SUBJECT: SAFETY EVALUATION FOR POINT BEACH NUCLEAR PLANT
UNIT 1, SUPPLEMENTAL ADDITION TO RELIEF REQUEST
MR 02-018-2 FOR CRDM REMNANT J-GROOVE WELD
REPAIR OVERLAP (TAC NO. MC3221)

Docket No.: 50-266

SAFETY EVALUATION BY THE OFFICE OF NUCLEAR REACTOR REGULATION
SUPPLEMENTAL REPAIR SUBMITTAL
RELIEF REQUEST MR 02-018-2
POINT BEACH NUCLEAR STATION UNIT 1
NUCLEAR MANAGEMENT COMPANY
DOCKET NUMBER 50-266

Figure 1

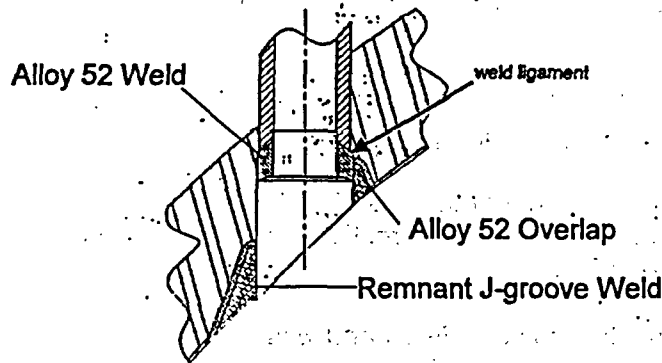
The Alloy 52 repair weld overlap on the Alloy 82/182 remnant J-groove weld condition noted by the licensee occurs due to the high radius of curvature for a Westinghouse two-loop design of the RVCH. Figure 1 below shows the condition which occurs on the uphill side of outer ring RVCH nozzles:

The licensee postulated that the remnant J-groove weld was completely cracked and that a 0.50" ligament of sound metal remained at the Alloy 52 weld overlap. The staff noted that the licensee had applied the Alloy 600 crack growth (MRP-55) rate to determine the amount of time before a postulated flaw in the remnant J-groove weld would grow through the ligament. The staff's conclusion is that using the MRP-55 model for this specific weld overlap configuration is not conservative, and that a more representative model will be gained by using an Alloy 82/182 crack growth rate.

In its supplemental letter dated May 15, 2004, in response to the staff's request for additional information, the licensee provided an analytical evaluation of the same configuration using the crack growth rate for Alloy 82/182 as the basis for the model in determining the amount of time involved for the postulated flaw to grow through the Alloy 52 ligament. The staff concludes that the use of the Alloy 82/182 crack growth rate is a more conservative representation for Alloy 52 since published information indicates that the crack growth rates are 5 - 6 times higher in Alloy 82 welds than in Alloy 600 nozzle materials. Secondly, since Alloy 52 and Alloy 82 are both coarse-grained austenitic welds, the 82/182 crack growth rate model is more representative than when compared to the rolled, annealed Alloy 600 material crack growth model. The subject calculation package, "Point Beach Unit 1 CRDM Top Head Analysis, PBCH-09Q-302," used the following assumptions:

The staff notes that published data verifies the appropriateness of the licensee's assumption that a 0.100" root defect may exist at the weld triple point of the Alloy 82, Alloy 600 and ferritic material of the RPV head. The results of the analysis indicated that assuming a 0.100" root defect contacts the fully cracked remnant, the time required for the assumed flaw to propagate through the remaining ligament would be 1.39 EFPY of operation. This is nearly the remaining amount of time the licensee will operate before retiring the RVCH from service since the

licensee intends to replace the Point Beach Unit 1 head after 1.5 EFPY of operation. Based on the conservative assumptions in the licensee's revised calculations, the staff concludes that it would take in excess of 1.5 EFPY for a flaw to propagate through the J-groove weld with an overlap condition, and is therefore acceptable.
